## INDIANA DEPARTMENT OF TRANSPORTATION

## STANDARDS COMMITTEE MEETING AGENDA

RE: Agenda for the May 19, 2005 Standards Committee Meeting

REVISION TO 2006 STANDARD SPECIFICATIONS

802-SNOC-05, Overhead Sign Details

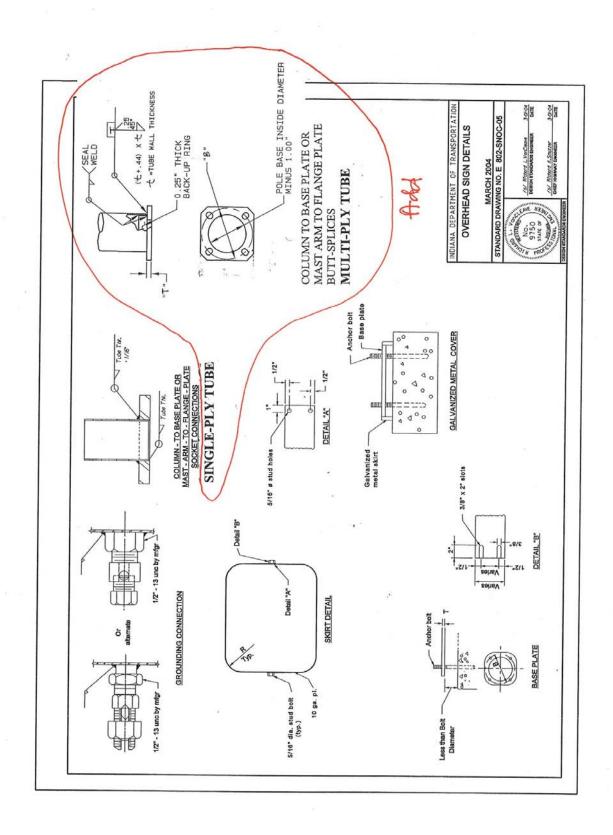
This revision adds a Multi-Ply Tube butt splice

We would like to make a revision on standards E 802-SNOC-05 and 802-SNOC-05. This revision would allow Contractors to use either socket joint for single-ply tube or butt splice for multi-ply tube. We believe this will increase bidding competition. We submit this proposed detail to the Spec. Committee for review and approval.
